# A TRANSNUCLEAR

E-22383  
May 20, 2005

Subject: RAI 2 Response for the NUHOMS® HD Storage System Docket No. 72-01030.  
(TAC No. L23738)

**REQUEST FOR ADDITIONAL INFORMATION  
TRANSNUCLEAR, INC.  
DOCKET NO. 72-1030**

Figure 1  
Finite Element Model and Boundary Conditions – WE 15x15

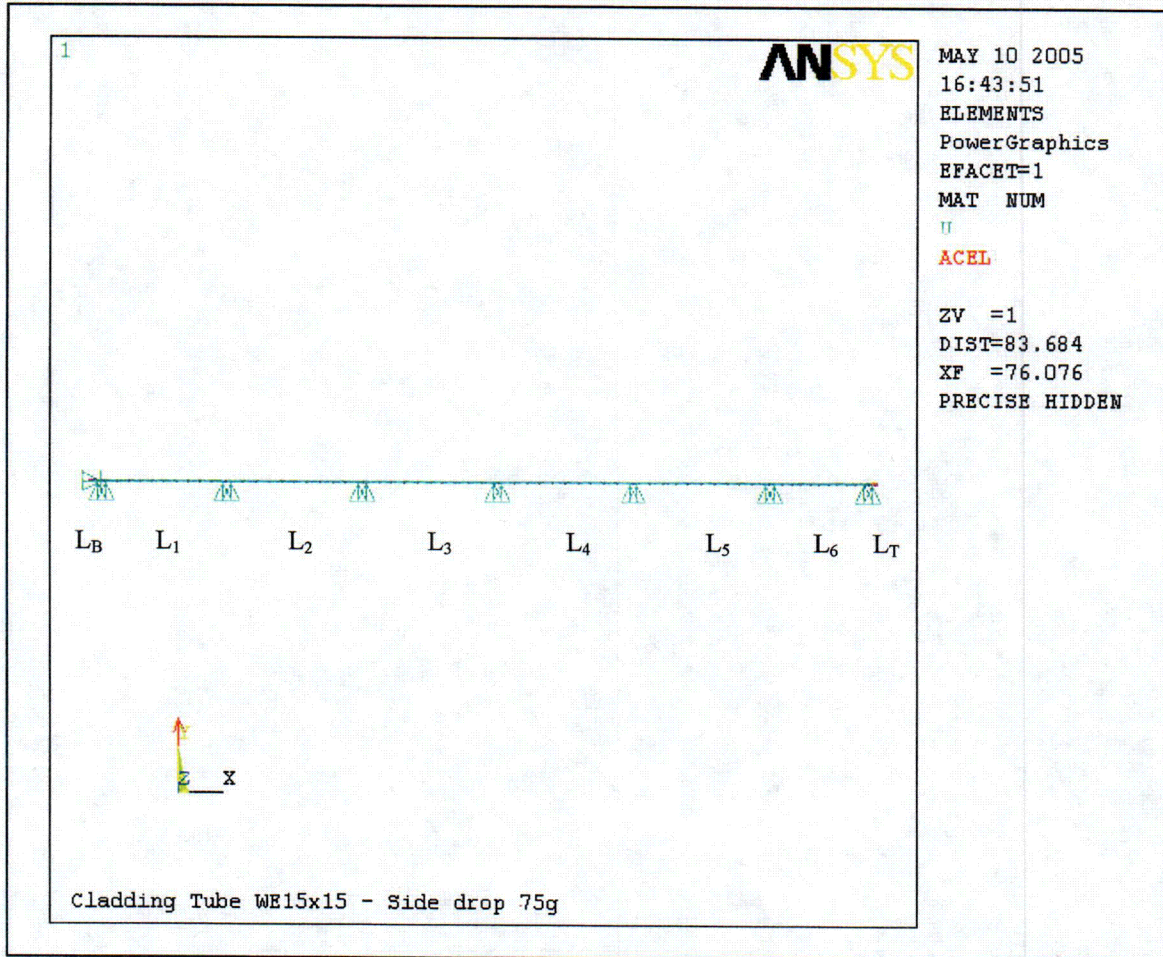
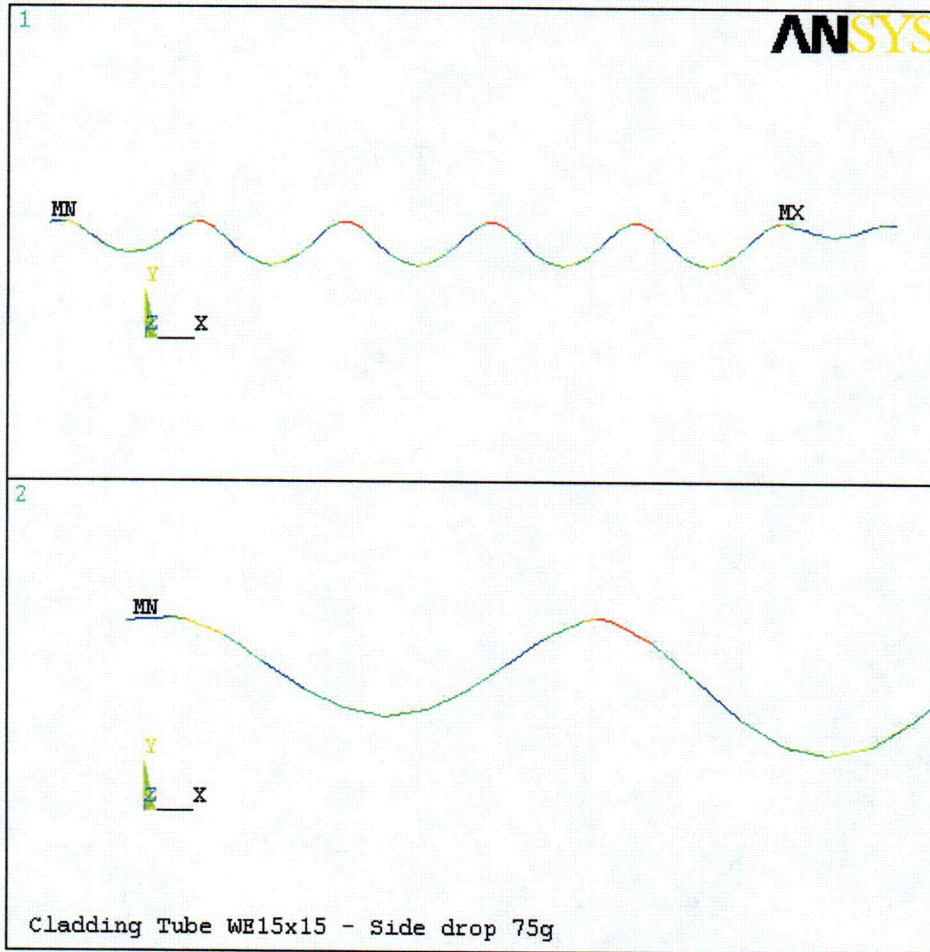
**Provide analyses demonstrating that fuel rod cladding integrity is maintained for the drop scenarios evaluated in SAR Section 3.5.3.1 "Side Drop" and Appendix 3.9.8, Section 3.9.8.11.1 "Structural Integrity Evaluation." Analysis assumptions should be justified based on the physical and behavioral characteristics of the fuel rods in the assemblies. Cladding material properties should be consistent with high burnup fuel and include a thickness reduction due to oxidation.**

First round RAI 3-13 requested justification for the fuel rod moment of inertia (MI) used in performing the side drop fuel rod structural integrity evaluation in Appendix 3.9.8, Section 3.9.8.11.1. Therein TN used a MI equal to  $\frac{1}{2}$  the MI of the cladding plus  $\frac{1}{2}$  the MI of the fuel. TN's response justified this approach by assuming composite behavior between the fuel and cladding based on physical conditions that exist during in-reactor operations that result in compressive radial stresses between the fuel and cladding. The staff found these in-reactor conditions to not be applicable to spent fuel in storage due to the significant difference in the pressure and temperature environments between in-reactor operation and storage conditions. (Essentially, in storage the fuel is in a highly fractured condition with little or no radial compression forces acting on the fuel.) It is also noted that in this first round response the applicant did not mention nor address the fact that for the drop analysis performed in Section 3.5.3.1 Table 3-12 the full MI of both the cladding and fuel was used.

After discussions with TN, the staff received a second analysis in an email dated March 25, 2005, (this second analysis is documented below) that did not rely on composite behavior between the fuel and cladding, and addresses both Appendix 3.9.8, Section 3.9.8.11.1 and Section 3.5.3.1 Part A of the second analysis addressed Appendix 3.9.8 – a one foot side drop load of 30g. This analysis treated the fuel rod as a continuous beam over multiple supports and considered the bending resistance (MI) of only the cladding. The staff found this approach acceptable. Part B of the second analysis addressed Section 3.5.3.1 Table 3-12 – a side drop load of 75g. For this analysis TN abandoned the approach used in Part A and instead pursued a displacement limited approach. TN assumed the fuel rod was not a continuous beam over multiple supports (the model that had been used in Part A), but rather assumed that it was a simply supported beam spanning between adjacent grid spacers – the most flexible condition possible – and imposed a displacement limit approximately equal to the maximum total gap between adjacent fuel rods plus the gap between the assembly and basket. Because of the simply supported beam assumption, the staff found the approach in Part B to be non conservative and inconsistent with actual fuel rod behavior during a side drop event and, therefore unacceptable.

An ANSYS [2] finite element model of the fuel rod is created for each fuel type, using PIPE16 elements. The finite element model geometry details and equivalent densities are computed in Table 1. The dimensions (lengths) of the fuel cladding for each fuel type are taken from reference [3]. The weight of fuel pellets is incorporated in cladding model by using equivalent densities. The weights of the top and bottom end fittings are distributed to the top and bottom spans of the fuel rod cladding models (Span  $L_T$  and Span  $L_B$  in Table 1). The typical finite element model and boundary conditions of fuel type WE15x15 are shown on Figure 1.

In an elastic analysis, 75g side drop load is applied as an acceleration. The maximum bending stresses for the fuel cladding from the ANSYS analyses are shown on Figures 2 to 6 and also summarized in Table 2.

Table 2 summarizes the maximum bending stresses from results of ANSYS 75g side drop analyses and axial stresses due to internal pressure. All the combined stresses are less than the yield strength of the cladding material (99,500 psi) with ample margin of safety.

Figure 7  
Typical Boundary Condition and Loading Plot of End Drop Buckling Analysis

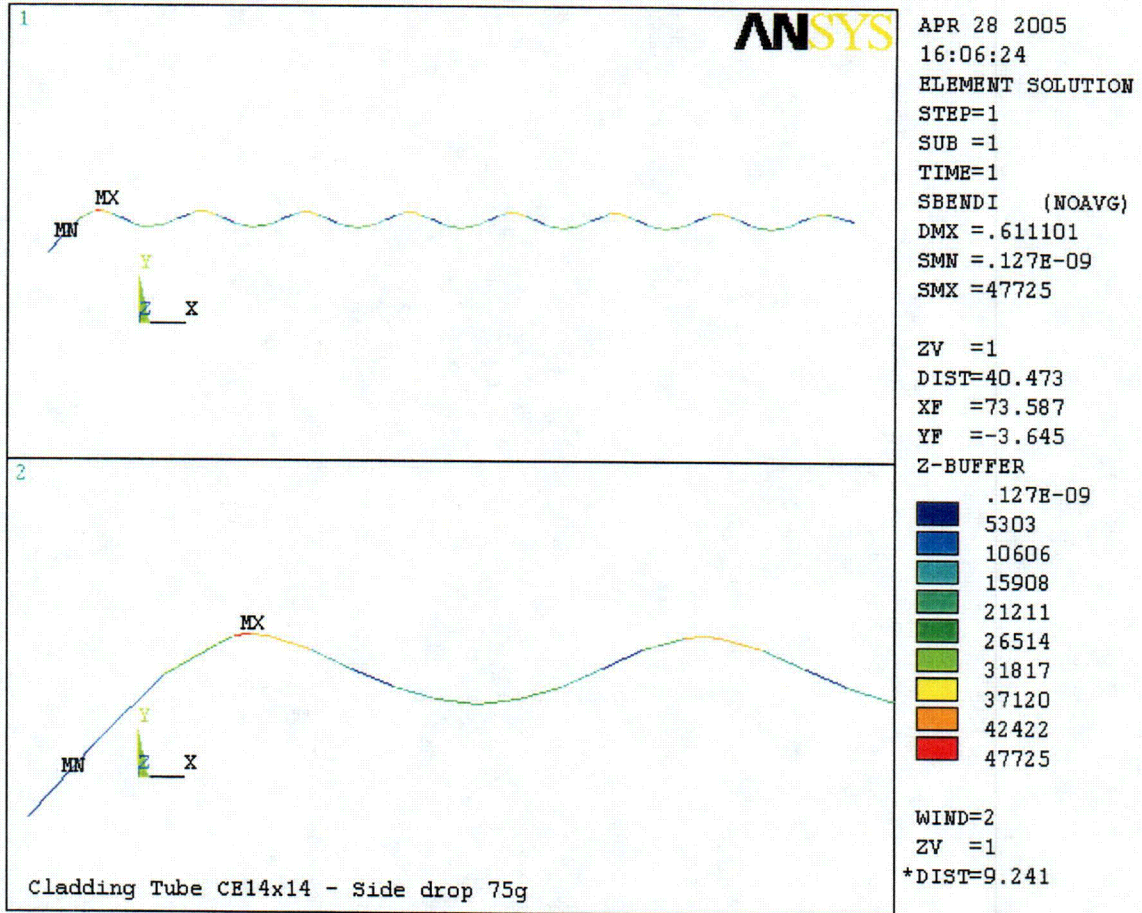
- 3-20 Provide an analysis demonstrating that fuel cladding integrity is maintained for the end drop event evaluated in SAR Section 3.5.3.2. Analysis assumptions should be justified based on the physical and behavioral characteristics of the fuel rods (cladding and fuel) in the assemblies. Cladding material properties should be consistent with high burnup fuel and include a thickness reduction due to oxidation.**

In Section 3.5.3.2 "End Drop" TN performed a static nonlinear ANSYS analysis of a simply supported fuel rod "column" with initial curvature loaded by an incrementally increasing axial force. Cladding and fuels were assumed to act as a composite (i.e., "fused with each other"). The cladding was given elastic-plastic properties and a tensile failure strain of 1.6%, while the fuel was given only elastic properties and no failure strain. Because the fuel has an elastic modulus more than twice that of the cladding and a solid cross-section, almost all of the lateral load resisting capacity ("buckling" strength) of the fuel rod, in the applicant's analysis, is provided by the fuel, not the cladding. The fuel is basically a coarse granular material with little tensile strength and therefore cannot be relied upon to resist tensile stress. This natural state of the fuel is not reflected in TN's analysis, which assumes that the fuel is a continuous solid with unlimited strength. The staff finds TN's analysis unacceptable.

The ANSYS large deformation option is used in the analysis. A ramped vertical inertial load is applied to the top of the ANSYS model. A small perturbation lateral load is applied at the mid point of the modeled cladding section to initiate a lateral deflection and to start buckling response of the fuel rod. Should the buckling of the fuel rod occur, the model becomes unstable and the ANSYS solution will not converge. The g load at the last converged sub-step solution in the ANSYS analysis is considered to be the critical axial buckling load.

The ANSYS model geometry and the applied load for each fuel rod type are listed in Table 4. A typical boundary condition and loading plot of the ANSYS buckling model are shown in Figure 7.

Table 4 summarizes the parameters used in the end drop buckling analysis of all specified fuel cladding and the g loads at which ANSYS produced the last converged solution before buckling. The minimum critical buckling load for all the specified fuel claddings is calculated to be 88g for WE17X17OFA fuel rod. It is above the design drop load of 75g with a safety factor of 1.17
